**CITY OF SHERWOOD  
JANUARY 12, 2022  
STAFF REPORT**

**SHERWOOD COMMERCE CENTER  
SITE PLAN REVIEW  
LU 2021-012 SP / CUP / VAR**

**To: City of Sherwood Planning Commission**

**From: Eric Rutledge, Associate Planner**

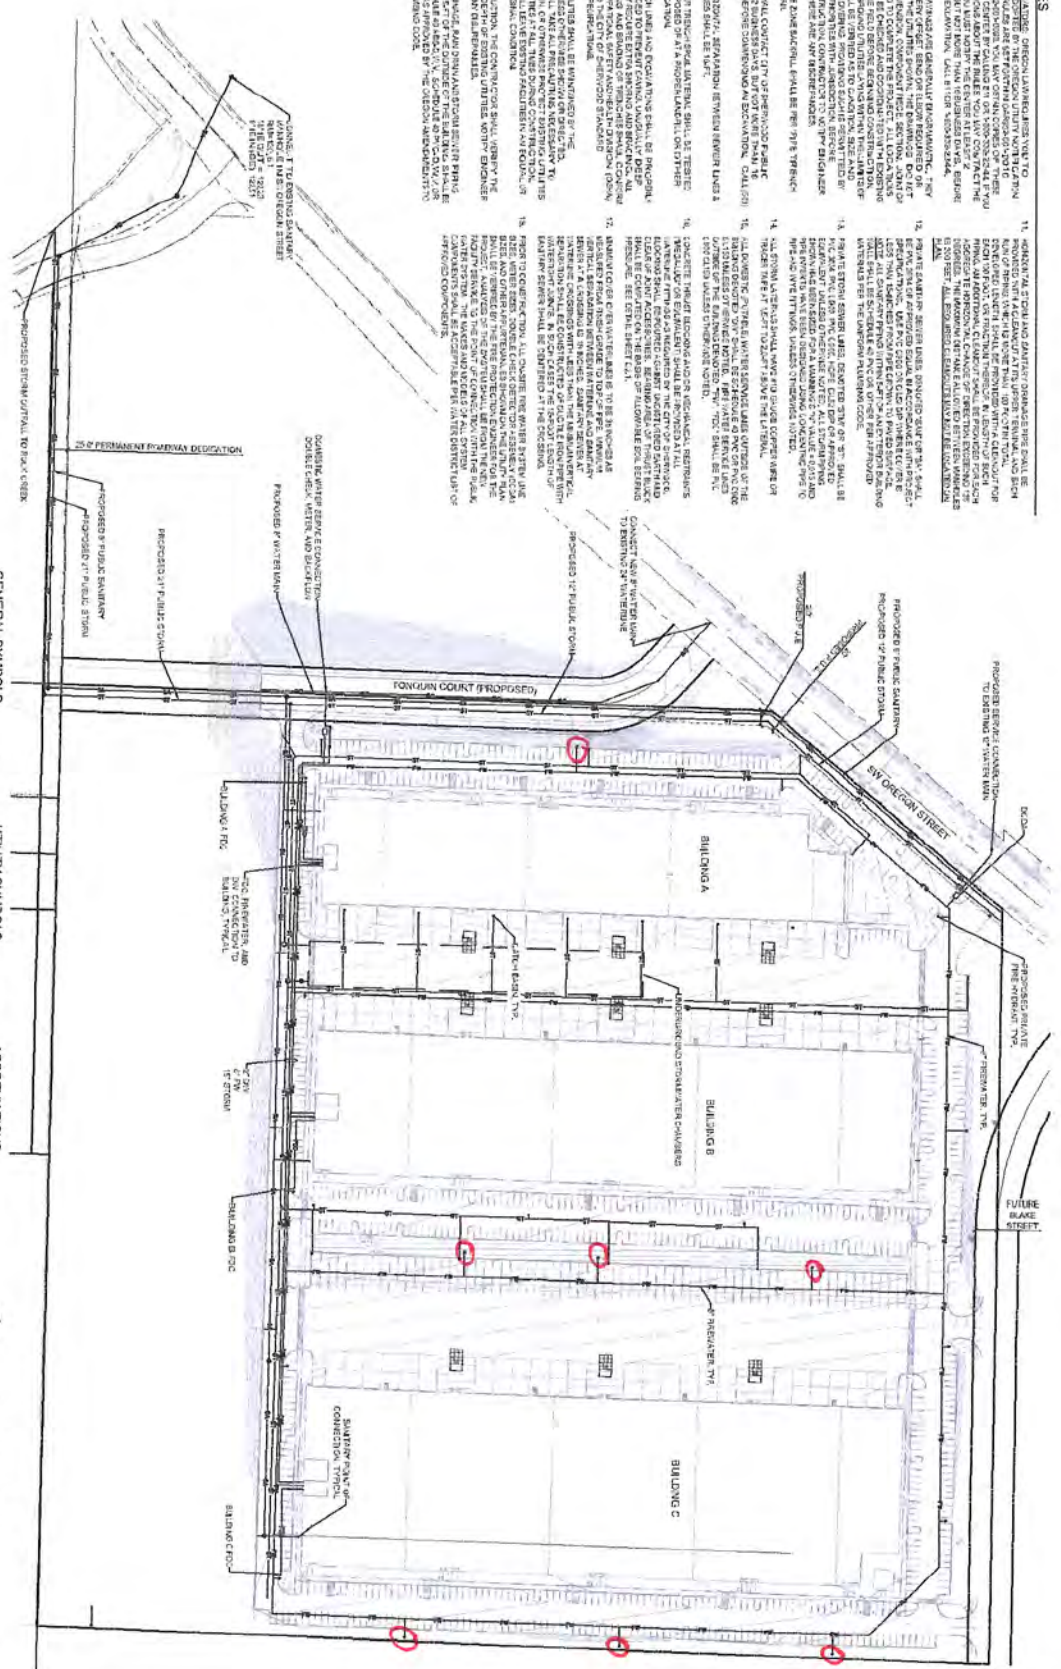
**Current utility plan Sheet D2 indicated locations of some fire hydrants that would be difficult to access because of parked vehicles. See attached sheet D2 for the fire hydrants in question.**
